UNITED STATES PATENT AND TRADEMARK OFFICE

APPLICATION NO.	FILING DATE	FIRST NAMED INVENTOR	ATTORNEY DOCKET NO.	CONFIRMATION NO.
10/047,613	01/15/2002	Karl Joachim Ebeling	M&N-IT 213	5759

Office Action Summary

DETAILED ACTION

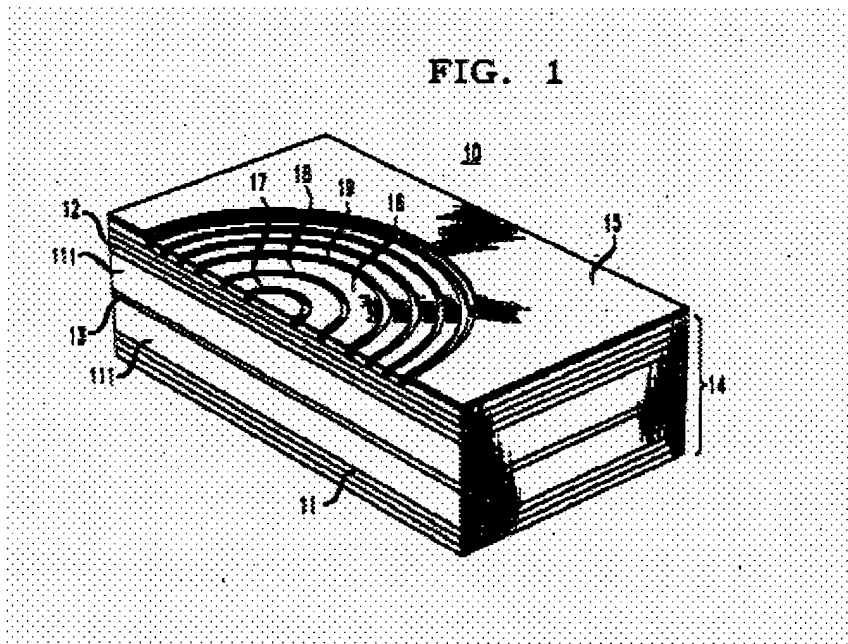
Claims 30 and 31 are rejected under 35 U.S.C. 102(b) as being anticipated by Vakhshoori (PN 5,426,657).

Regarding claim 30,

Figure 1 illustrates a vertical cavity surface-emitting laser (VCSEL) [applicant's vertical resonator] having a top surface (16) [applicant's beam profile shaper] with

multiple trenches (17,18,19...) [applicant's relief structure] (column 2 lines 32-35 and lines 40-44), which affect the reflectivity for selecting the transverse mode [applicant's mode selection] (column 2 lines 54-58).

Regarding claim 31,

Column 2 lines 44-47, discloses the trenches as Fresnel zones [applicant's Fresnel lens].
